ADDENDUM No. 2

**ITT CS-19-11
SHELL-GLEN FIRE HALL EXTERIOR REPAIR**

Addendum No. 2 is being provided in clarification to ITT CS-19-11 released October 2, 2019.

PARTIAL NORTH WALL ELEVATION - ADDENDUM 2

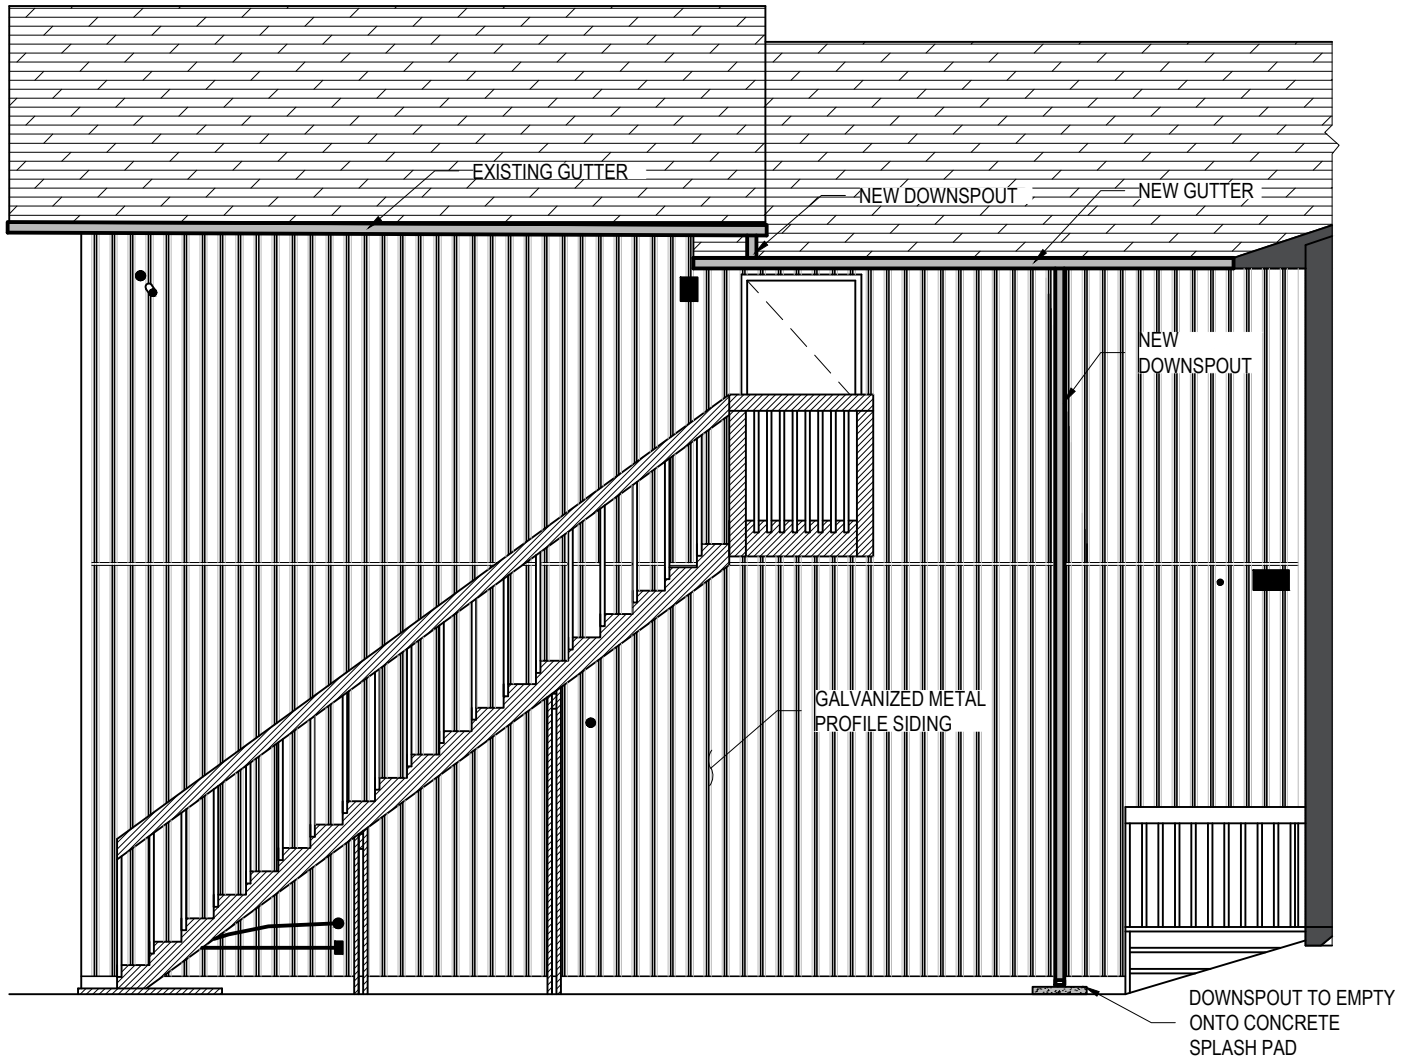
Please see the attached drawing showing the new gutter and downspout assembly on the partial North wall of the Shell-Glen Fire Hall.

NOTE: RENOVATION OF GUTTER ON NORTH WALL OF ORIGINAL BUILDING
 ADD NEW DOWNSPOUT FROM EXISTING GUTTER ON UPPER PORTION TO
 NEW GUTTER ON LOWER PORTION OF ROOF . REPLACE PARTIAL GUTTER
 ON LOWER PORTION OF ROOF WITH NEW FULL LENGTH GUTTER. ADD NEW
 DOWNSPOUT AND CONCRETE SPLASH PAD.
